Access Compliance Report

Public Rights-of-Way

(Curb Ramps)

Intersection ID: 8350	Main Street: LASALLE_ST	Cross Street: CUSTER_ST	Location: NE
ADA ID: F599C3C370D2	Ramp Type: PerpDiag	Initial Pass/Fail: Fail	Overall Compliance: No
		Severity Score: 35

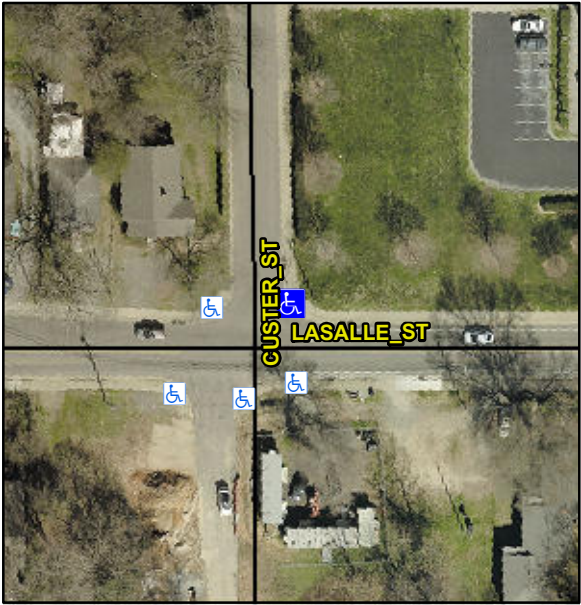
Codes/Mitigation Info/Possible Solution			Field Measurements/Component Compliance		
	Possible Solutions:		Compliance	Description	Data
	Remove & Replace Curb Ramp With Two New Directional Ramps or Equivalent.		No	Ramp Length (in)	59.5
			No	Ramp Width (in)	39.0
			N/A	Flare Type LT	N/A
			N/A	Flare Slope LT (%)	N/A
			N/A	Flare Traversable LT?	N/A
			N/A	Landing Length (in)	N/A
			N/A	Landing Width (in)	N/A
			N/A	Landing Slope (%)	N/A
			N/A	Landing X Slope (%)	N/A
			N/A	Landing Curb? (Y/N)	N/A
			N/A	Shared Landing?	N/A
			N/A	Gutter Ponding?	N/A
			N/A	Gutter Lip Ht (in)	N/A
			N/A	Painted X Walk1?	No
				X Walk 1 Direction	To W
			N/A	X Walk 1 Width (in)	N/A
				X Walk 1 Slope (%)	1.6
				X Walk 1 X Slope (%)	3.7
			N/A	Ramp inside XWalk1?	N/A
<p>Surveyor Notes:</p> <p>N/A</p> <p>PROW/ADA:</p> <p>Not Found, R304.5.1, R304.2.2, R304.5.3</p>			N/A	Ramp inside XWalk2?	N/A
				Road Slope (%)	1.6
				Road X Slope (%)	0.7

N/A	Any Obstructions?	N/A
				Obstruction Type	
			N/A		N/A
			Yes	Surface Condition? (G/P)	Good
